MARCH 8TH 2019 TO JANUARY 2022
TECHNICAL BULETIN TECH076 REVISION C
FULL DISTRIBUTION

Important information for replacing Two Stage Series Turbos as used on Renault R9M Gen2 1.6 litre Euro 5 & Euro 6b engines for Trafic / Vivaro / NV300 vehicles.

IMPORTANT REPLACEMENT INFORMATION FOR HP AND LP TURBOS

Old obsolete HP Turbo
821943-5002S

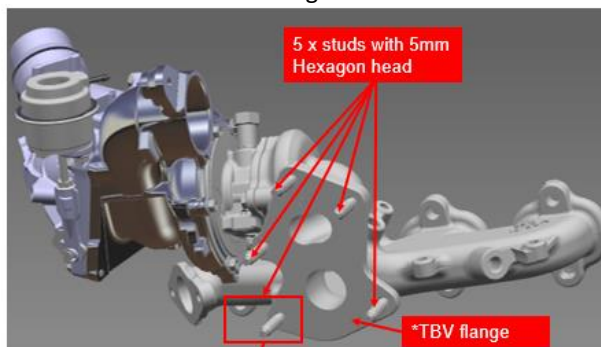
821943-5002S with Torx E7 studs

New HP Turbo 821943-5003S

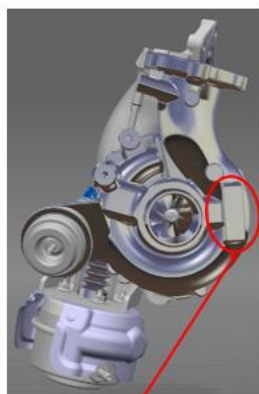
821943-5003S with Hexagon head studs

Configuration of LP Turbos:

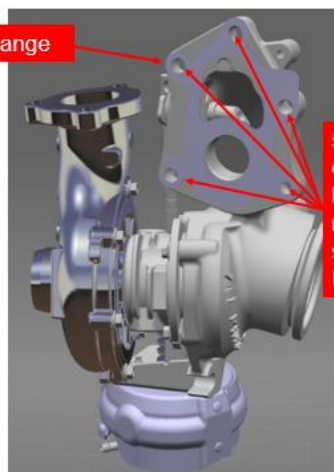
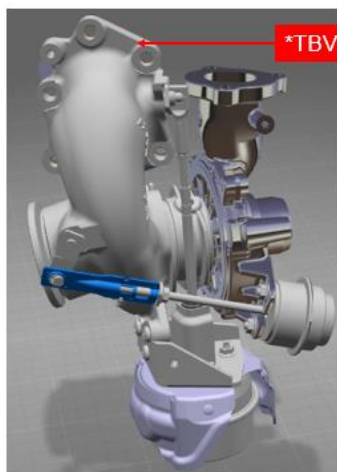
821942- 5007S, -5009S, -5010S with old turbine housing material

821942-5011S & 883861-5002S with new turbine housing material

Note: all LP turbos look the same, so check part number from nameplate on compressor housing or check casting marks as shown on next page

Identification of LP Turbos:

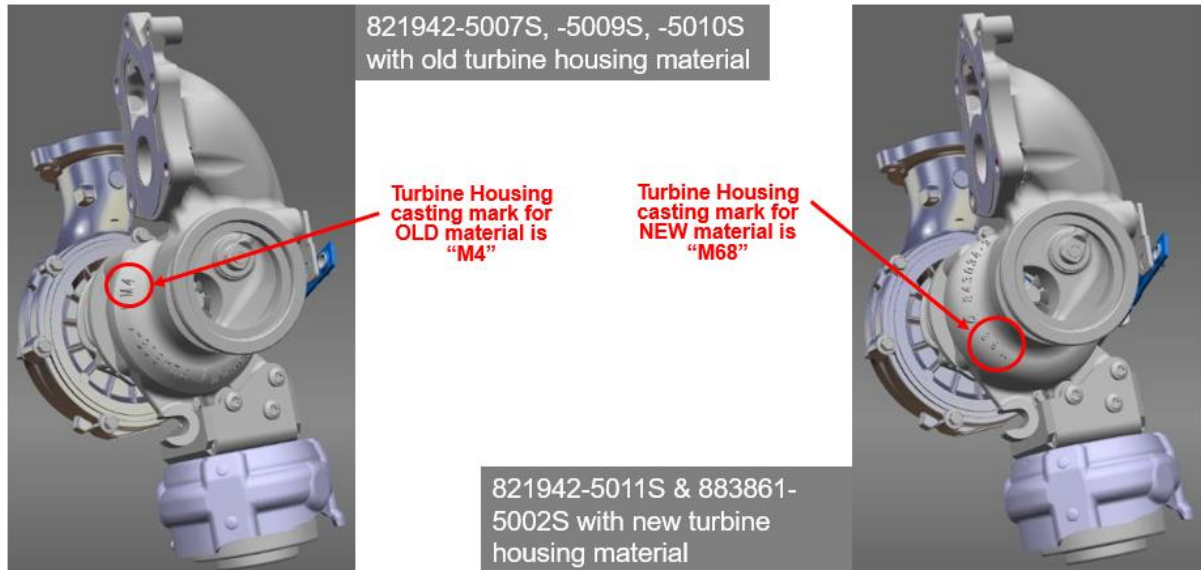
Left: 821942- 5007S, -5009S, -5010S with old turbine housing material.

Right: 821942- 5011S & 883861-5002S with new turbine housing material.
